UNITED STATES PATENT AND TRADEMARK OFFICE

APPLICATION NO.	FILING DATE	FIRST NAMED INVENTOR	ATTORNEY DOCKET NO.	CONFIRMATION NO.
10/594,315	06/27/2007	Lawrence C. Kennedy	032968-0134	2098

Office Action Summary

DETAILED ACTION

Monroe '809 discloses, referring to Fig. 1, a viscous fluid clutch for use in a vehicle comprising:

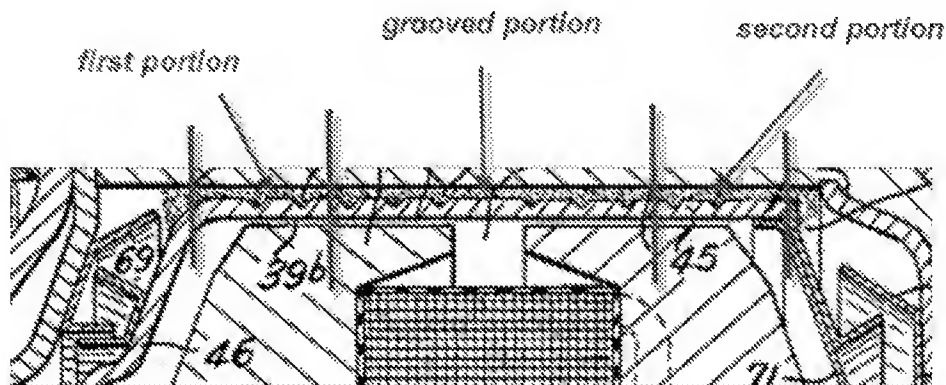
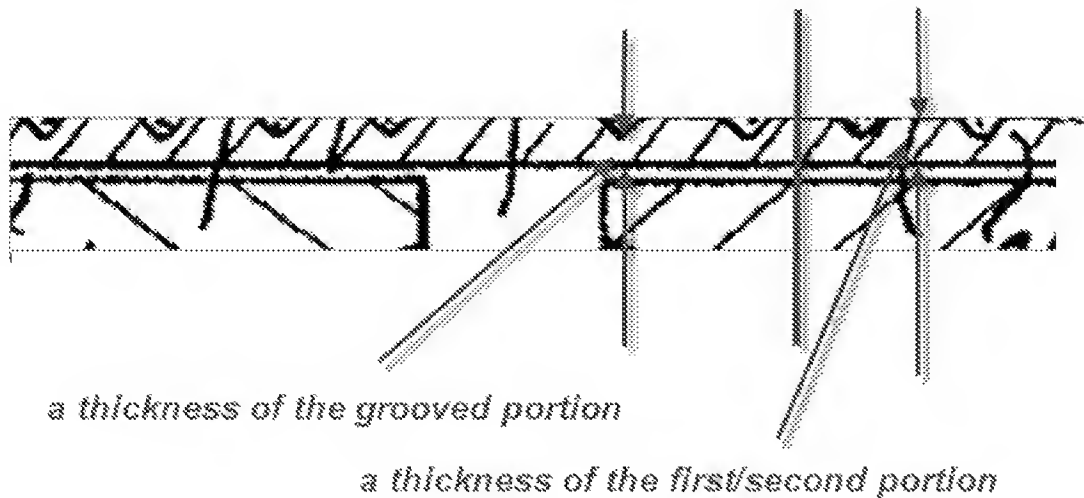
- a rotor (rotor 20) having a rotor hub (46) driven by an input shaft (input 21) and a rotor surface having an end connected to an outer periphery of the rotor hub,
- the rotor surface including: a first portion; a second portion; and a grooved portion disposed between the first and second portions (Fig. below);
- wherein the first portion, the second portion, and the groove portion are formed by a single piece,
- wherein the grooved portion forms a W-shaped profile (the grooved portion shown below and in Fig. 1 forms at least two W-shaped profiles),

- wherein the first and second portions of the rotor each have a thickness sufficiently greater than a thickness of the grooved portion (See Fig. below) such that a magnetic flux path in the fluid clutch will have a substantial portion of a magnetic field flow around the grooved portion as compared to a portion of the magnetic field flow that flows through the grooved portion.

In Monroe, the grooved portion has a thickness that appears to be about half as thick as a thickness of the first and second portions, which makes the thickness of the first and second portions in question sufficiently greater, even substantially greater than a thickness of the grooved portion.
